## Independent Technical Audit of Los Alamos National Laboratory for Compliance with the Clean Air Act, 40 CFR 61, Subpart H in 2001

DOJ File Number: 90-5-1749A

Case Name: *CCNS v DOE*

October 2002

**Figure 2.** CALPUFF modeling domain showing location of Site D (Stack 3002919), meteorological towers (TA 6, TA 41, TA 49, and TA 53), terrain elevations (in meters), and CAP-88 receptors (shown by crosshairs).

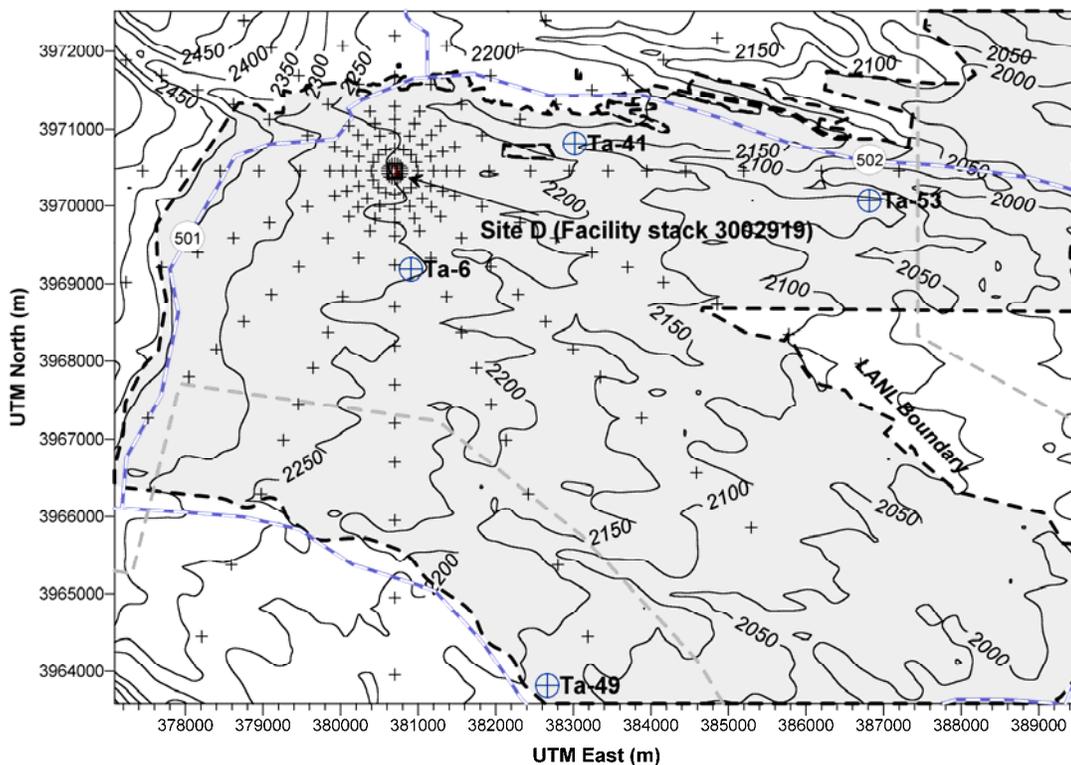
The issue of complex terrain modeling was raised in the first two audits, and again during this third audit. The question from IEER involves the applicability of a Gaussian plume model for a region with complex terrain such as LANL.

As a means of exploring this issue during the second audit, we calculated the ratio of the air concentration ( $\chi$ ) divided by the source term ( $Q$ ) for CAP-88 and the complex terrain model, CALPUFF. The ratio of concentration divided by source term is referred to as the Chi over Q ( $\chi/Q$ ). The CALPUFF model explicitly treats spatial variability in terrain and meteorological conditions. The comparison focused on annual emissions from Site D (facility stack 3002919) in a 12.42 km  $\times$  8.92 km model domain using meteorological data from 1999 for the CALPUFF simulation and a 5-year meteorological data set for the CAP-88 simulation (Figure 2). A limitation to this methodology was that CALPUFF  $\chi/Q$  values were obtained from the computation node nearest the CAP-88 receptor location. The CALPUFF computational grid had a spacing of 175 m between grid nodes, and resulted in a potential error of  $175 \text{ m}/2 = 87.5 \text{ m}$  between the location of the CAP-88  $\chi/Q$  and that of CALPUFF. As part of the third audit investigation, we corrected this inaccuracy and reevaluated the results along with an evaluation of terrain effects on estimated concentrations.

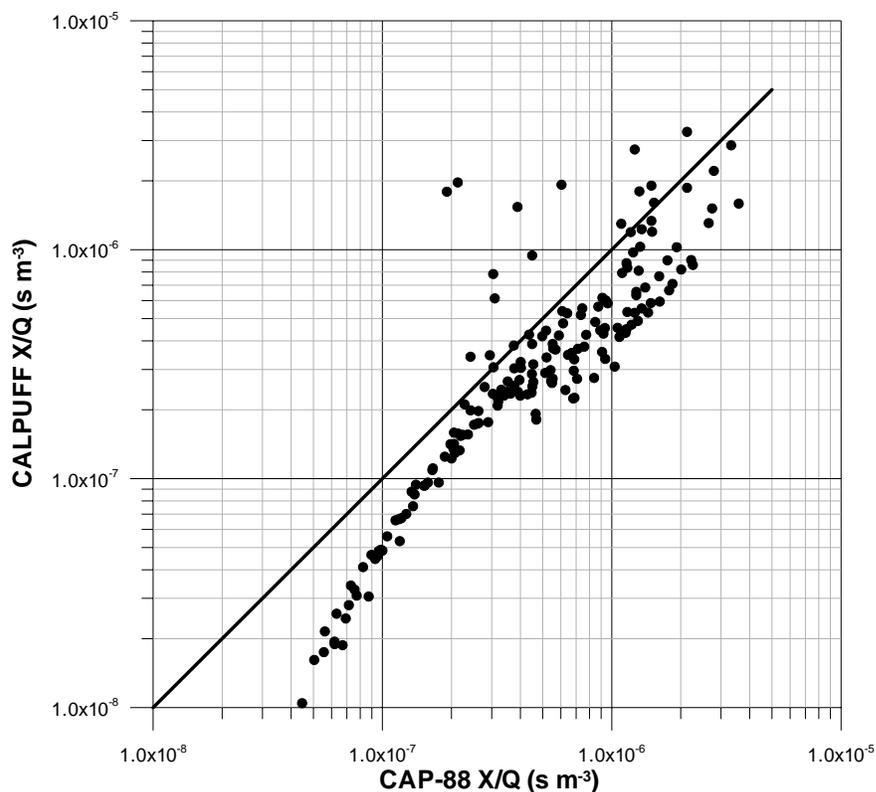
Annual average CALPUFF  $\chi/Q$  values were generally lower than those calculated with CAP-88 (Figure 3). Higher  $\chi/Q$  values indicate less plume spreading and, consequently, higher pollutant concentrations. On average, CAP-88  $\chi/Q$  values were a factor of 1.85 higher than those calculated with CALPUFF. Approximately 9% (16 out of 179 values) of the CALPUFF/CAP-88  $\chi/Q$  ratios were greater than one, and of those 16 ratios, only seven were greater than two. A CALPUFF/CAP-88  $\chi/Q$  ratio  $>1$  indicates the CALPUFF  $\chi/Q$  is higher than the CAP-88 value. Twelve of CALPUFF/CAP-88  $\chi/Q$  ratios greater than one were 100 m from the source, two were 300 m from the source, and the remaining two were 3.75 km from the source. However, CALPUFF/CAP-88  $\chi/Q$ 's ratios at the 3.75 km distance were  $\leq 1.02$ , which means the  $\chi/Q$  values from both codes were essentially the same.

**Figure 4.** South-to-north cross section of terrain and annual average  $\chi/Q$  values for CALPUFF and CAP-88. Terrain is represented by the shaded area.

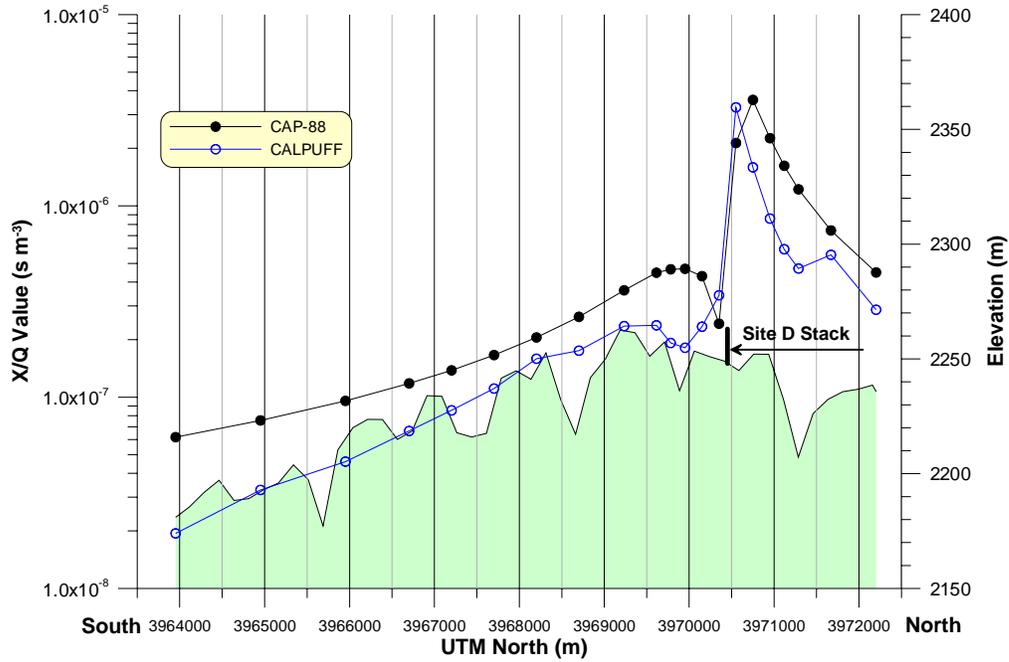
Differences between CAP-88 and CALPUFF  $\chi/Q$  values as a function of distance and direction from the source are shown in Figures 4 and 5. The terrain elevation has been superimposed on these graphs so that effects of terrain can be visualized. Figure 4 shows the south to north cross section of the annual-average  $\chi/Q$  values. Note that the CAP-88 curve exhibits plume lofting over the 100-m receptor while the CALPUFF curve does not. Undulations in the CALPUFF curve are noted to occur at locations where the receptor was in the bottom of a canyon. Most notably, the receptors near Universal Transverse Mercator (UTM) coordinates 3970000 and 3972000 exhibit a drop in the  $\chi/Q$  value followed by a rise in  $\chi/Q$  value at the next downwind receptor. These undulations are suspected to be terrain induced. Both models have substantially higher  $\chi/Q$  values north of the stack compared to south presumably due to the predominance of winds from the south.

**Figure 5.** West-to-east cross section of terrain and annual average  $\chi/Q$  values for CALPUFF and CAP-88. Terrain is represented by the shaded area.

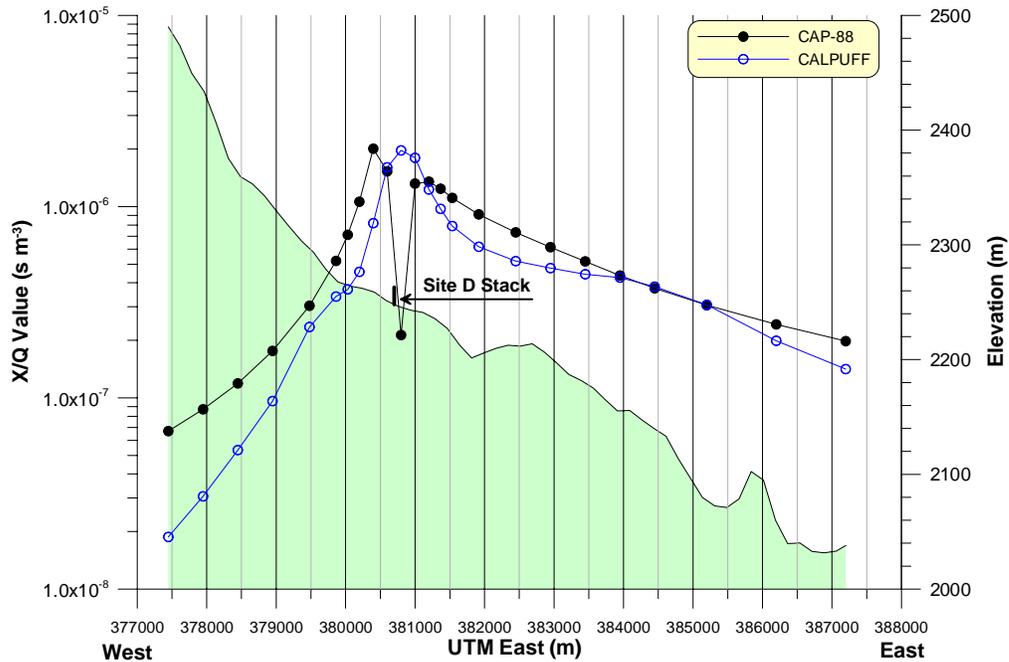
The west to east cross section (Figure 5) depicts a slightly different pattern. There are few deep canyons that cut the cross section and the terrain slopes from west to east. Chi over Q values decrease sharply west of the stack. This sharp decline in  $\chi/Q$  values appear to be a result of the meteorological conditions and not the influence of terrain, because both models exhibit similar behavior. East of the stack, concentrations drop-off slowly with distance for both models.

**Figure 6.** Twelve-hour average CALPUFF  $\chi/Q$  values as a function of distance south from the Site D stack.

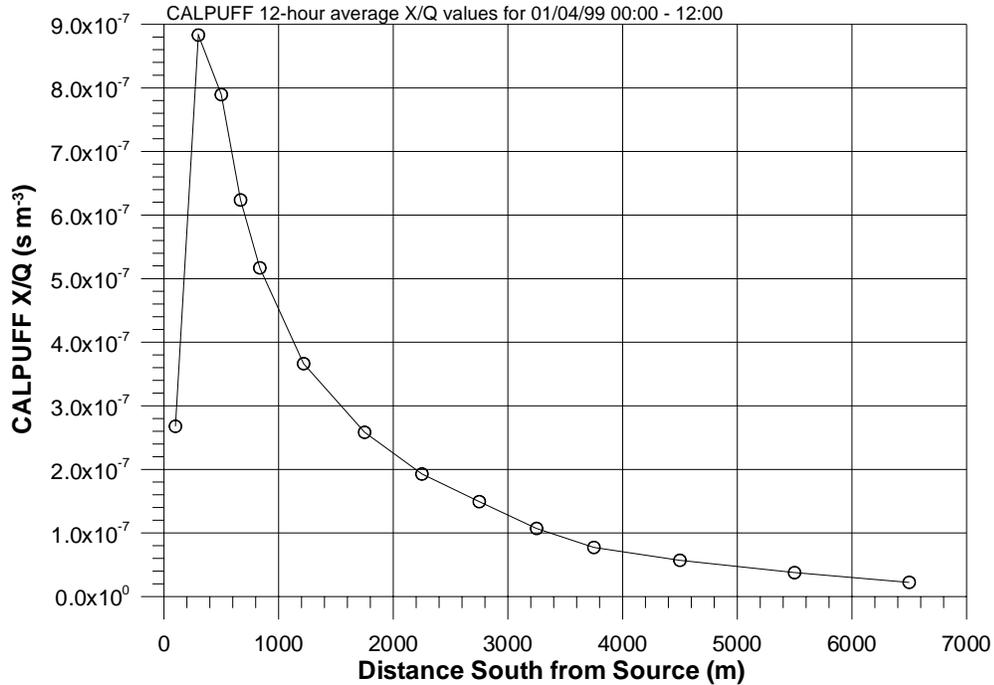
One feature that is absent from the CALPUFF  $\chi/Q$  values is the effect of plume lofting near the source. Originally, it was thought that the CALPUFF grid may have been too coarse to resolve plume lofting. Further investigation revealed that plume lofting occurs in the CALPUFF model for short-term averages (Figure 6), but is apparently absent when annual averages are considered. Therefore, grid resolution may not be as important as originally thought in terms of resolving plume lofting. One important distinction between the two models is that in CALPUFF, the plume may double back on itself. That is, if the wind direction shifts about 180 degrees, then the material emitted in the previous hour can advect toward the source, and thereby impact receptors near the source. It was not verified that the higher CALPUFF  $\chi/Q$  values near the source were due to the plume doubling back on itself and it was beyond the scope of this exercise to investigate it any further. Nevertheless, these effects are incorporated into the CALPUFF  $\chi/Q$  values. CALPUFF  $\chi/Q$  values that significantly exceed those of CAP-88 are limited to receptors close to the source (<300 m). The nearest potential public receptor was estimated to be 600 m to the northwest of the Site D stack on State Highway 501.

Overall,  $\chi/Q$  values calculated by CAP-88 provide conservative estimates of dispersion at distances  $>300$  m from the stack for annual average emissions. For some close-in receptors ( $<300$  m), CALPUFF calculated higher dispersion factors. However, the nearest public access is estimated to be  $\sim 600$  m from the stack, and therefore, CAP-88 would still provide a conservative estimate of annual-average dispersion at this distance.
